**#2021-117**

## **Walmart Final PUD Amendment**

### **Project Review for Planning and Zoning Commission**

Final Planned Unit Development Amendment to allow exterior changes to the building façade with an additional sign variation for increased signage, a building addition and changes to the site for a new fulfillment pickup area.

| NEW SIGNAGE SCHEDULE                  |          |          |              |              |                 |                  |
|---------------------------------------|----------|----------|--------------|--------------|-----------------|------------------|
|                                       |          |          |              |              |                 | <b>455.56 SF</b> |

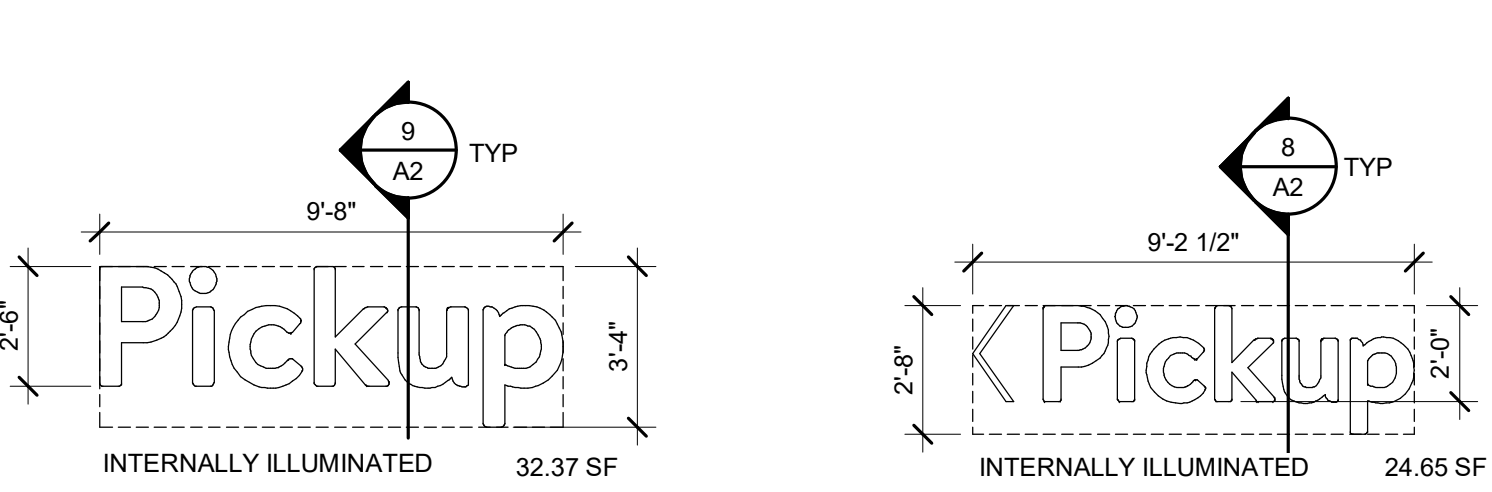
- A small addition is added to the north side of the building, with all exterior materials and colors matching the existing façade appearance.
- A blue canopy with signage will help direct customers to this location.
- Staff is recommending adding a white top cap and step down architectural feature around the “Pickup” sign similar to the “Automotive” sign.

- The blue canopy contains two “Order online, Pick up here” signs. Each sign is 22 square feet for a total of 44 square feet.
- A new Pickup sign will be installed above the canopy area. This wall sign is only 32.37 square feet in area, but the entire blue box is calculated and that size is 350 square feet.
- The signage schedule lists a new total building signage of 455.56 square feet that does not include the entire blue box. Figuring the total existing and new signage with the blue box equals 773.19 square feet of signage.
- Some pick up signage from the front elevation is being removed and the inclusion of the entire blue box is a net increase in 351.89 square feet of signage.

The way signage is calculated, it includes painted areas like the blue background. Although the text portion of the sign area is only 32.37 square feet, the calculated signage is 350 square feet. The petitioner can request this variation as part of the PUD approval.

1. Approved plans, reflecting staff and advisory board recommendations, as approved by the City Council:
  - A. Application (Rico, received 07/29/21)
  - B. Elevations, [sheet A2, A2.1, Rendering] (pb2 Architecture+ Engineering, dated 06/18/21, received 07/12/21)
  - C. Site Plan (Carlson Consulting, dated 06/18/21, received 07/12/21)
2. Work with staff to replace any dead or dying landscape on the Walmart site.
3. Create a white cornice cap over the "Pickup" area, similar to what is found over the "Automotive" area.
4. Stripe the new customer pickup parking spaces at 19 feet long.
5. The petitioner must address all of the review comments and requirements of the Community Development, Fire Rescue, Police, and Public Works Departments.
